VILLAGE OF LOMBARD
REQUEST FOR BOARD OF TRUSTEES ACTION
For Inclusion on Board Agenda

TO: VILLAGE PRESIDENT AND BOARD OF TRUSTEES
FROM: Scott Niehaus, Village Manager
DATE: February 22, 2021 (B of T) **Date:** March 18, 2021
TITLE: Amendment to Village Board Policy 6.C. – Street Lighting Policy
SUBMITTED BY: Carl S. Goldsmith, Director of Public Works

SUBJECT: Amendments to Village Board Policy 6.C. - Village Standard Lighting Policy

Village Standard Lighting

Rev. 08/04

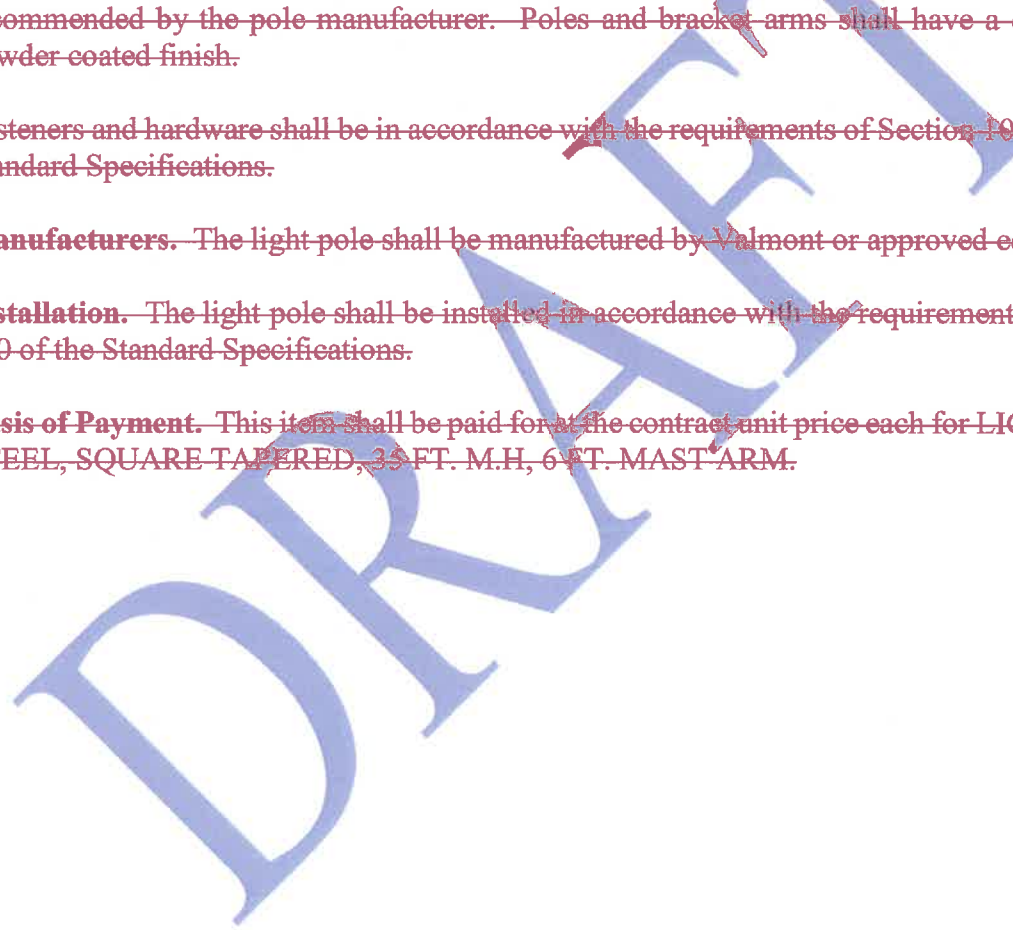
Description. ~~This work shall consist of furnishing and installing square tapered light poles complete with bracket arm and all required hardware including bolt covers.~~

Material. ~~The thirty five foot light pole shall be a 7 gauge square tapered shaft (nominally 8" x 4") formed from a single steel sheet. The bracket arm shall be square tapered (nominally 4" x 3 3/8"), 6' long and have a 2" round slip fitter attachment. Poles shall have a 4" x 6" handhole with vandal resistant cover and shall be provided with a square base cover. Poles shall have a duplex receptacle with weatherproof enclosure. 4 1/2" x 3/8" hot dipped galvanized anchor bolts shall be furnished with each pole. The bolt circle shall be 13 1/2" or as recommended by the pole manufacturer. Poles and bracket arms shall have a dark bronze powder coated finish.~~

~~Fasteners and hardware shall be in accordance with the requirements of Section 1088.03 of the Standard Specifications.~~
